Manual Supplement

Manual Title: VT02 Users
Print Date: October 2012
Revision/Date:

Supplement Issue: **2**
Issue Date: 11/12
Page Count: 3

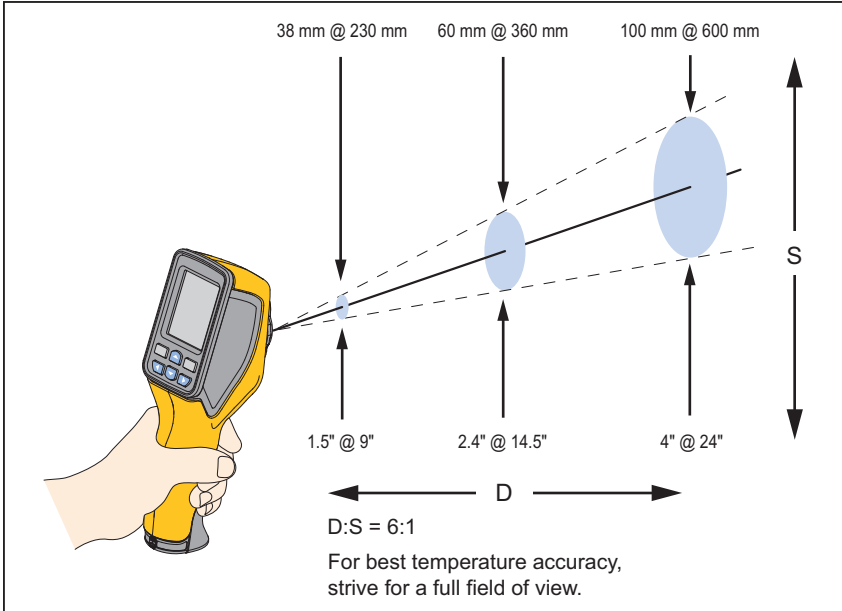
On page 4, replace the Note 1 with:

- [1] Fluke recommends the micro SD memory card that is supplied with the Product. Fluke does not warrant the use or reliability of aftermarket SD memory cards of different brands or capacities.

Temperature Measurement Accuracy

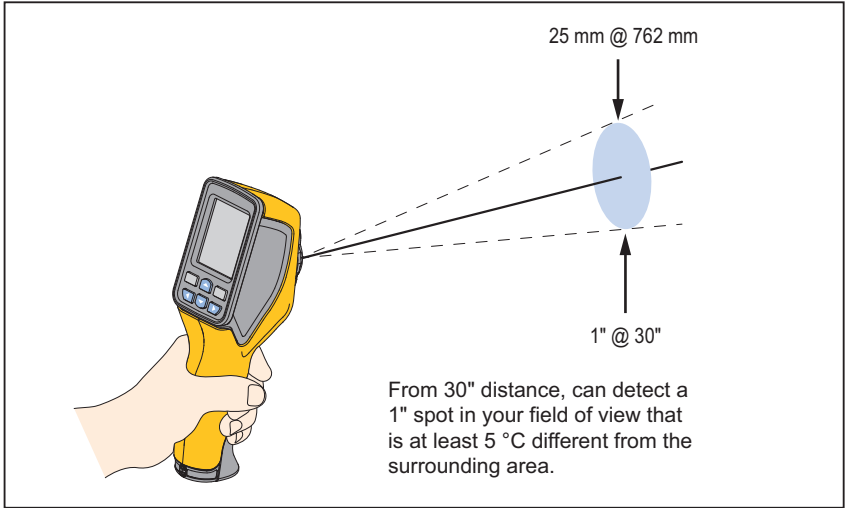
On page 11, following **Temperature Measurement**, add the following figures:
